Can-Am Spyder 2024-25 Backup Camera Retrofit / Turn Off- 144022

Help document on retrofitting the backup camera to some MY 2024-25 Can-Am Spyder or turning it off after software update

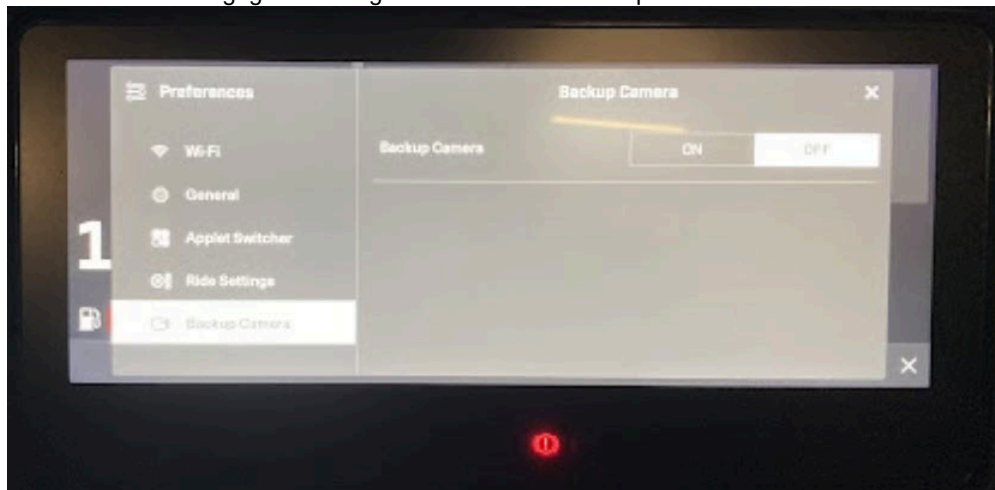
The connector should be just to the left of the backup light.

Retrofit the corresponding MY25 rear fender along the backup camera kit 219401199 (refer to shop manual for procedures)

Spyder RT: **Rear Fender** 1x 219800618 **Bracket** 708304955 (included in 219401199)

Spyder F3 T/LTD: **Rear Fender** 1x 219800607 **Bracket** 708304953 (included in 219401199)

Cluster will need to be updated the to MY25 software 710010643 or BRP Connect V3.1.0 if done Over The Air
